# ADMINISTRATIVE SUBDIVISION PLAN - M-NCP&PC No. 620210040

9119 Redwood Avenue  
Lot 1A + Part of Lot 1, Block 3  
Kefauver Tract Bradley Hills  
Proposed Lots A, B & C  
Administrative Subdivision Plan  
Administrative Subdivision  
Plan No. 620210040

RE: Administrative Plan No. 620210040  
9119 Redwood Avenue

Re: **COMBINED SWM CONCEPT/SITE  
DEVELOPMENT STORMWATER  
MANAGEMENT PLAN** for  
9119 Redland Avenue  
SM# 286432  
Administrative Subdivision Plan # 620210040  
Tract Size/Zone: 1.647 ac./ R-200  
Total Concept Area: 1.647ac./71,738 sq.ft.  
Lots/Block: Lot1A and Part of Lot 1/Bradley Hills  
to be subdivided into three lots  
Watershed/Class: Cabin John Creek/Class I  
Type of Development: New Development

AP-4

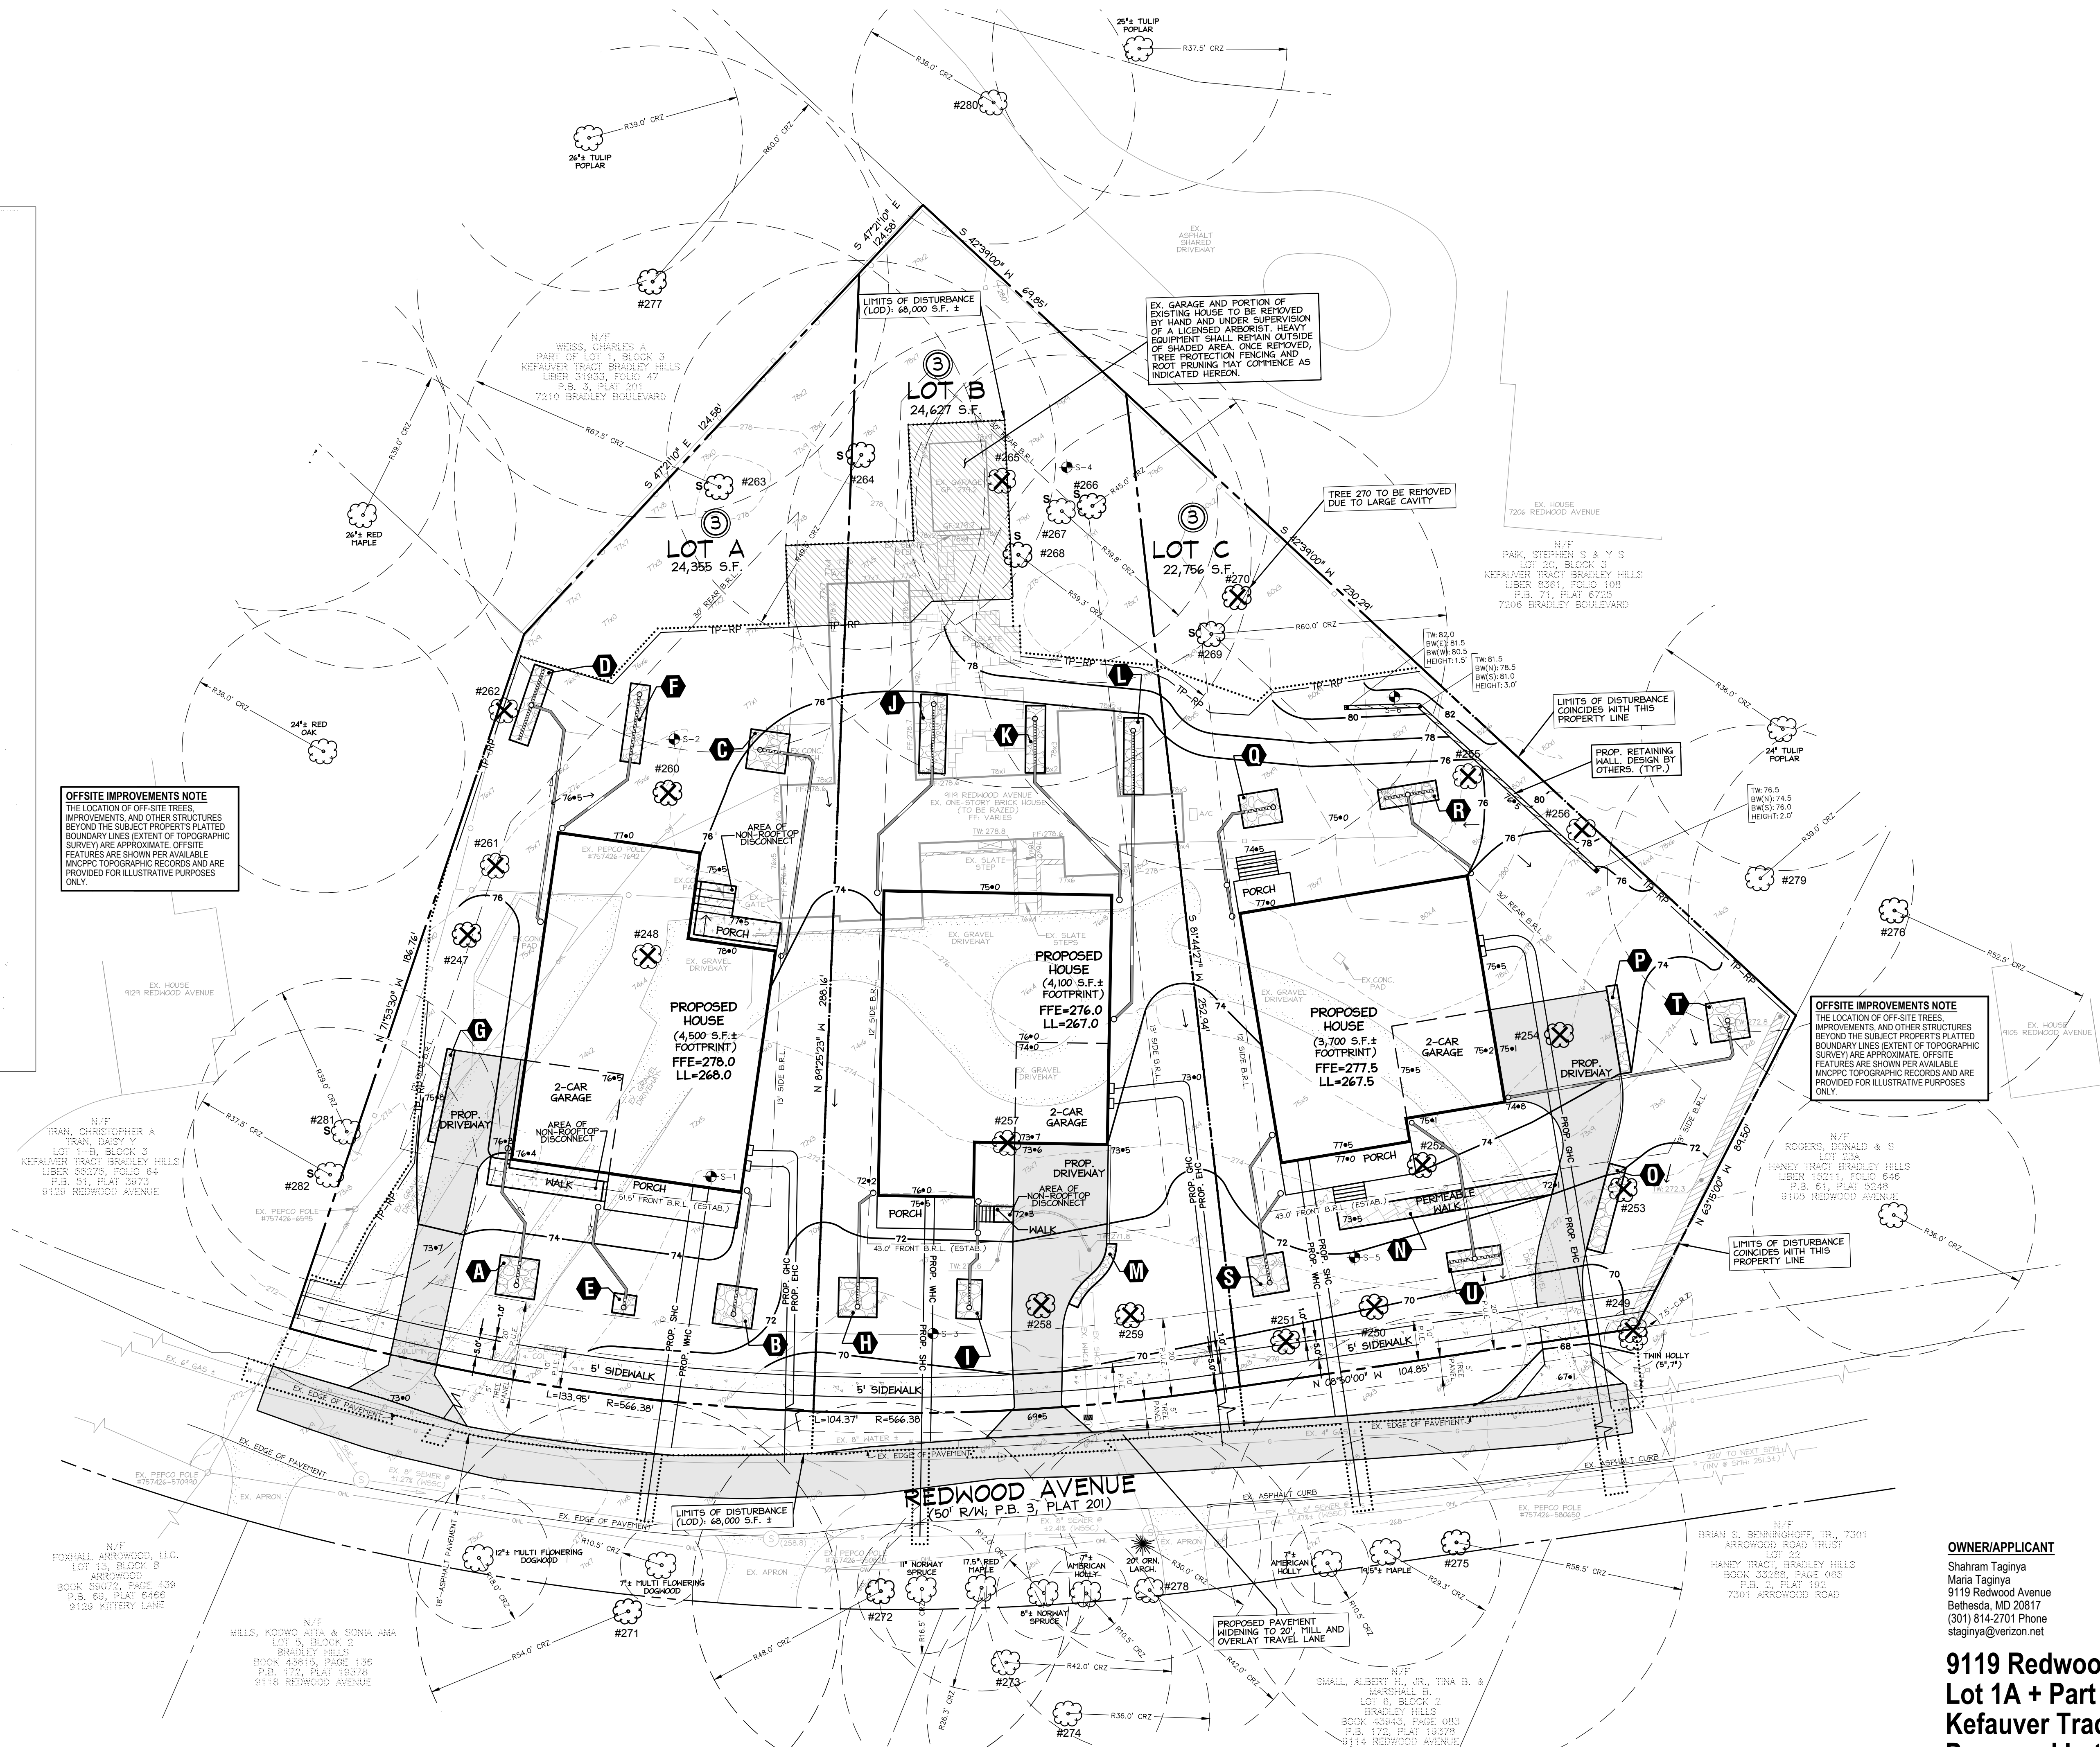
2. The Redwood Avenue pavement will need to be widened to a minimum twenty (20) feet along the property frontage per MCDPS Fire & Rescue requirements. On the Certified Administrative Subdivision Plan, dimension and label the proposed pavement as twenty (20) foot minimum.

3. On the Certified Administrative Subdivision Plan, revise the cross-section detail for Redwood Avenue to show a five (5) foot rather than four (4) foot sidewalk.

4. Provide a ten (10) foot wide Public Improvement Easement (PIE) and twenty (20) foot wide overlapping Public Utilities Easement (PUE) along the existing Redwood Avenue frontage.

5. Add a north arrow to the Certified Administrative Subdivision Plan.

11. Provide a minimum five-foot continuous clear path (no grates) sidewalk along the Redwood Avenue frontage.
12. Posting of a right-of-way permit bond is a prerequisite to DPS approval of the record plat. The right-of-way permit will include, but not necessarily be limited to, the following improvements:
